**R E M A R K S**

**RE: THE DRAWINGS**

FIG. 4

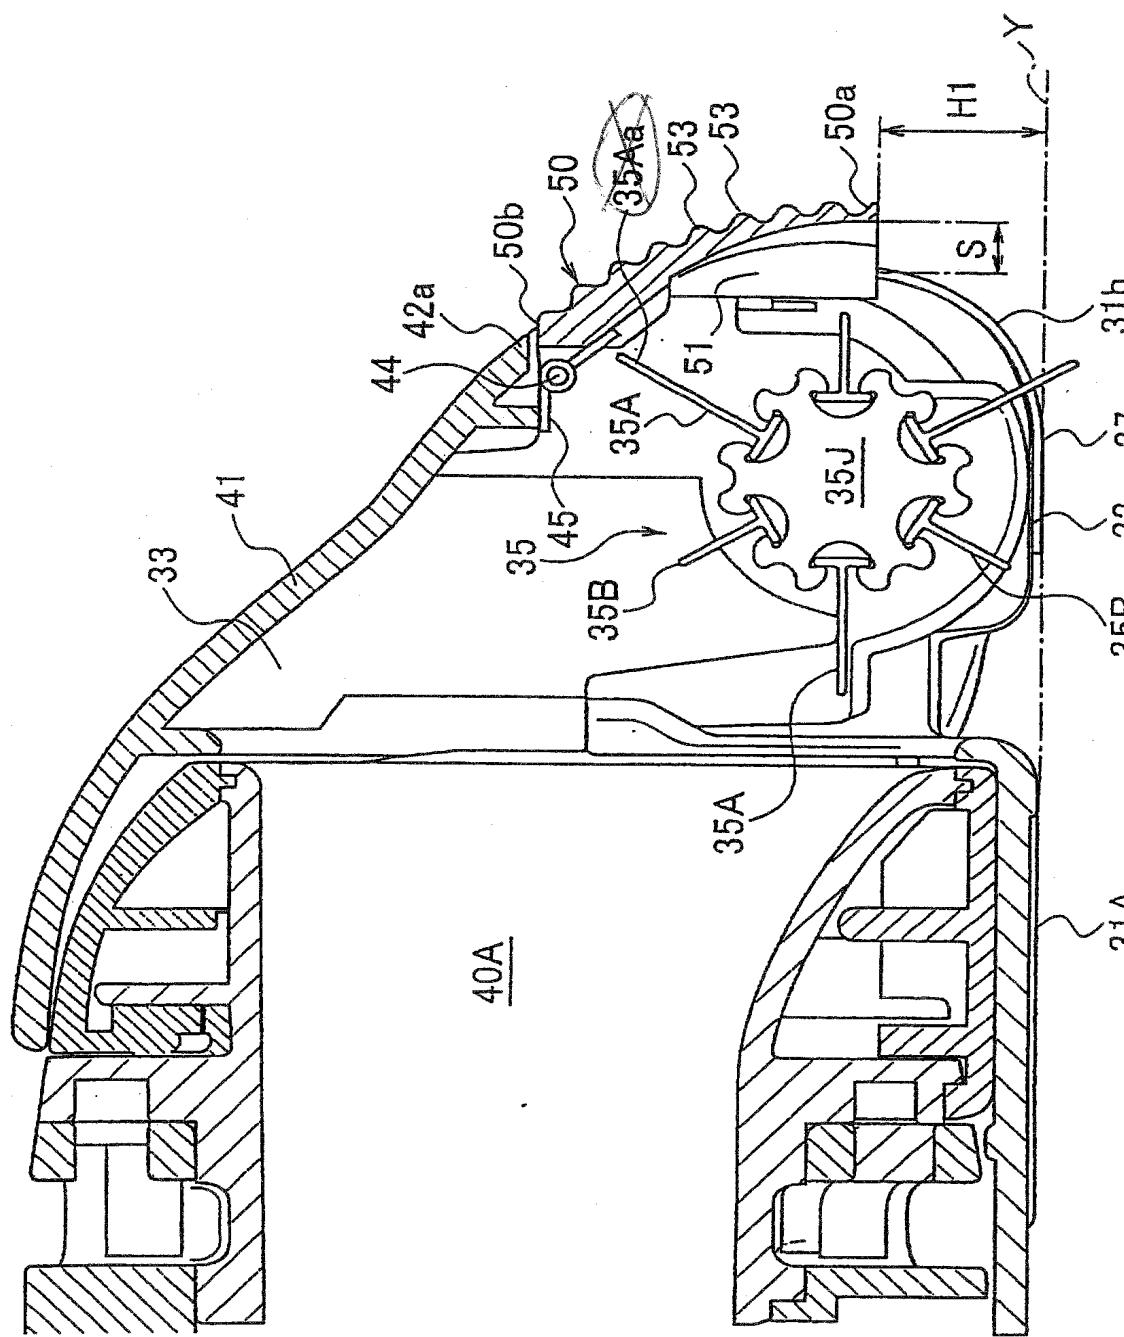
Fig. 10 has been amended to be labeled as "PRIOR ART" as required by the Examiner, and Figs. 4, 8 and 9 have been amended to remove reference numeral "35Aa". In addition, it is noted that the specification has been amended at paragraph [0031] to delete reference numeral "40a" and the specification has been amended at paragraphs [0027] and [0031] to mention reference numeral "40A" shown in Figs. 4-6. Accordingly, it is respectfully submitted that the Examiner's objections to the drawings have been overcome. Submitted herewith are corrected sheets of formal drawing which incorporate the amendments and annotated sheets showing the changes made thereto.

**FIG. 8**

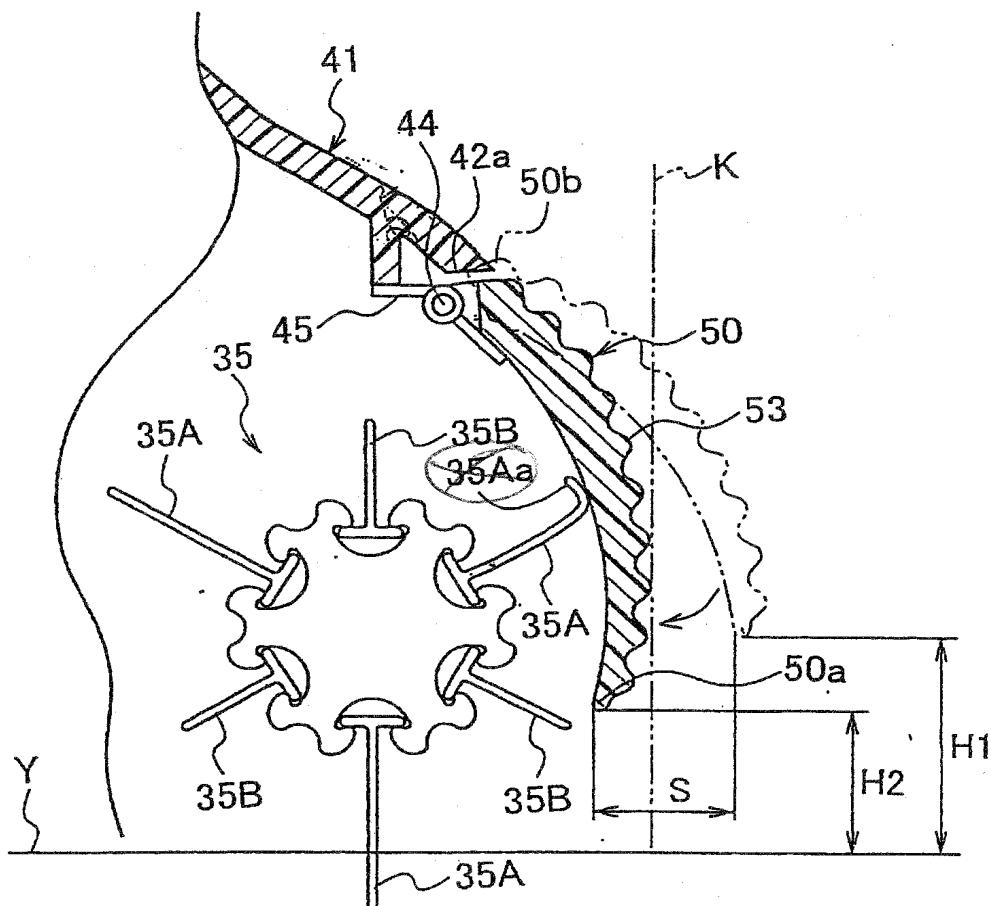
With this structure of the claimed present invention, as shown in Figs. 8-9, when the suction inlet unit (30) is advanced forward to press the cover (50; the first part of the wall section) against the wall (K), the cover (50) is rotated by the adjusting mechanism in the clockwise direction of Fig. 8 and the

**FIG. 9**

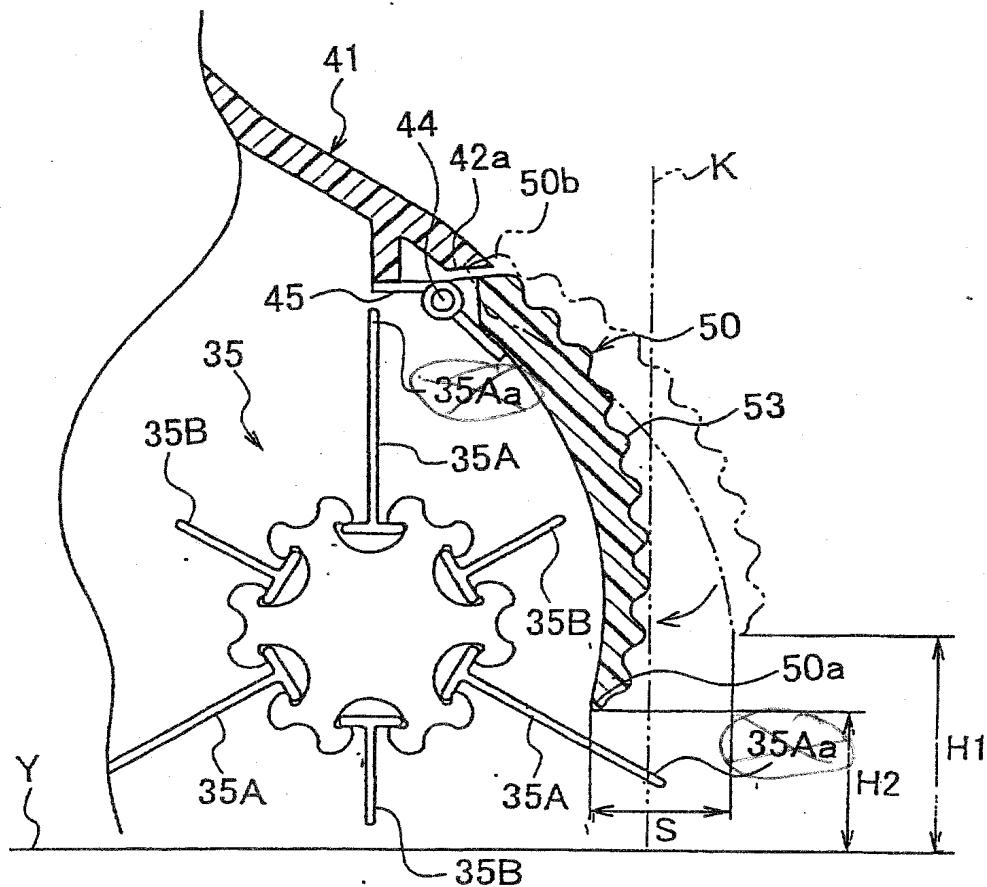
non-rotatable front end surface (Va) of the bumper (V) comes into contact with the wall (K) to prevent further inward rotation/movement of the cover (50). As a result of the rotation, the opening area of the front suction inlet (46) decreases and a part the longer cleaning members (35A) on the rotating cleaning body (35) protrudes out through the front suction inlet (46) ahead of the cover (50) as shown in Fig. 9.
